Central Planning Authority

Agenda for a meeting of the Central Planning Authority to be held on **19 June 2024 at 10:00am** in Conference Room 1038, 1st Floor, Government Administration Building, 133 Elgin Avenue

CPA/17/24

Figure 2. The application site with the parcel boundary highlighted in blue and an overlay of the submitted modification plans (Aerial Imagery Source: UKHO, 2021 & Architectural Plans Source: Steve Madramootoo, 2024).

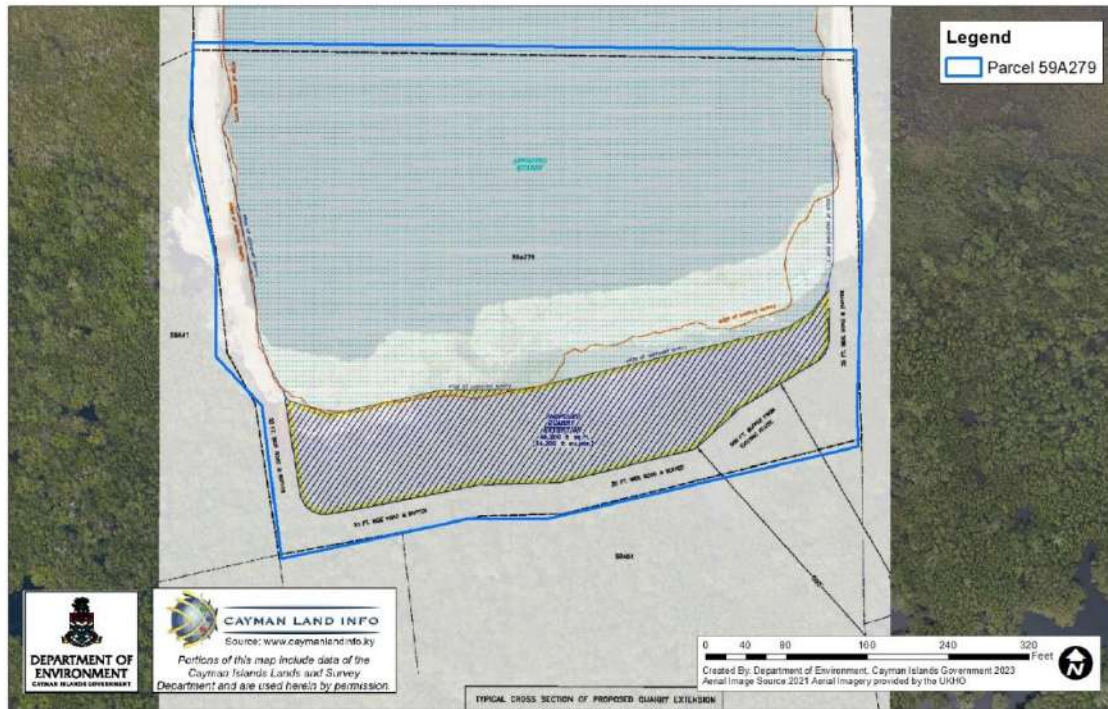
As seen in Figure 2 below, the proposed modification will result in an extension of the quarry into the mangrove vegetation on-site.

The applicant is reminded that mangroves are Schedule 1, Part 2 Protected Species under the National Conservation Act (NCA) with an adopted Conservation Plan. It is an offence to remove mangroves unless permission is explicitly sought to remove them either through the granting and implementation of planning permission or a National Conservation Council Section 20 permit. The Mangrove Species Conservation Plan can be downloaded at the following link: <https://conservation.ky/wp-content/uploads/2021/01/Species-Conservation-Plan-for-Mangroves-FINAL.pdf>.
